**SOUTHWEST CHULA VISTA
CIVIC ASSOCIATION**

DOCKET
07-AFC-4

RE: Comments on Alternatives Section of the PSA for the public record:

MegaWatts Per Square Mile and Percent NonWhite Population, Natural Gas & Landfill Gas Facilities Only

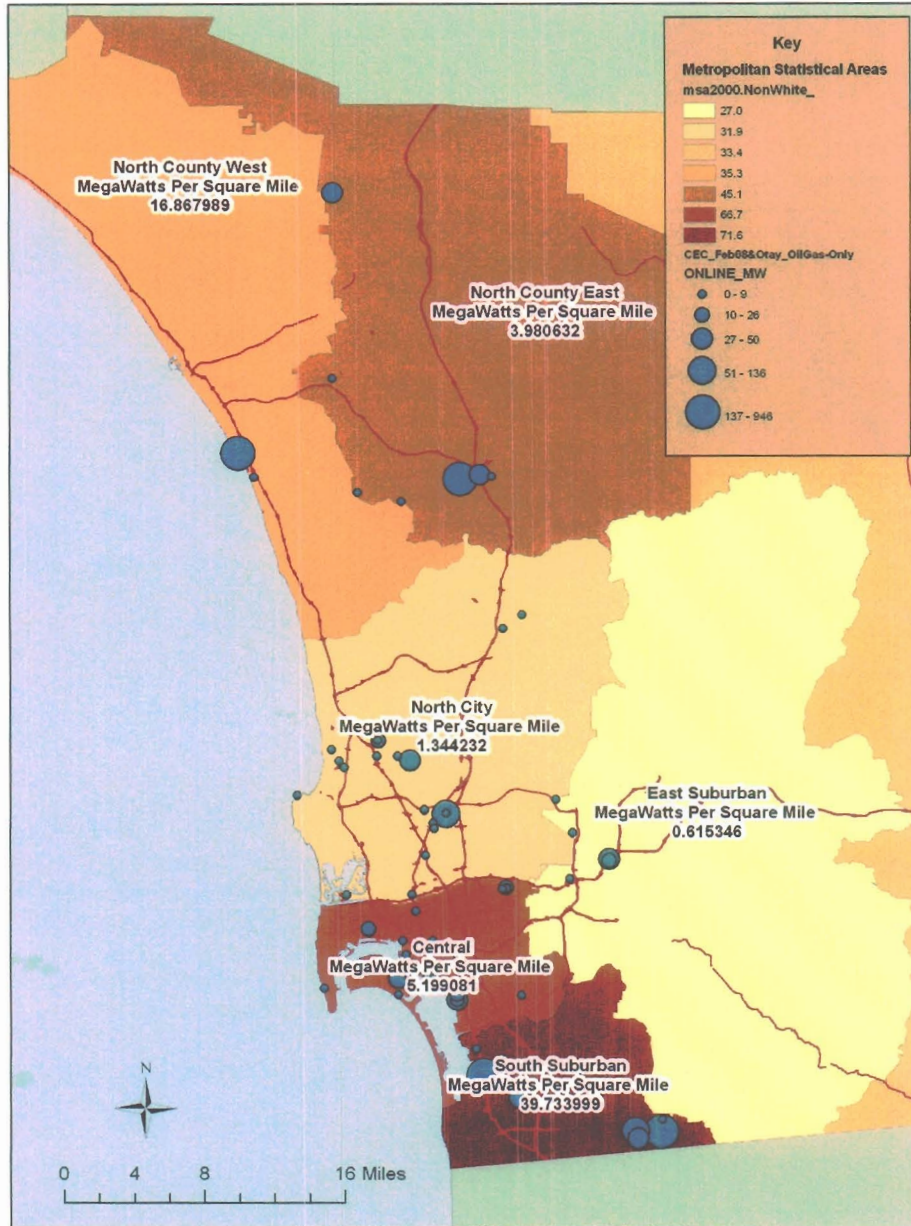
SDG&E has said that there is no need for peaking power in the southbay as the map below shows. ISO has said the the RMR status of the SBPP will not be removed unless Otay Mesa comes on line and either two peakers further north or The Sunrise Powerlink come on line. In any case it will not close before 2010. CVEUP has no relationship to closing SBPP. This statement needs to be removed from the FSA. Therefore, staff's conclusions are not correct and need to be rewritten for the FSA.
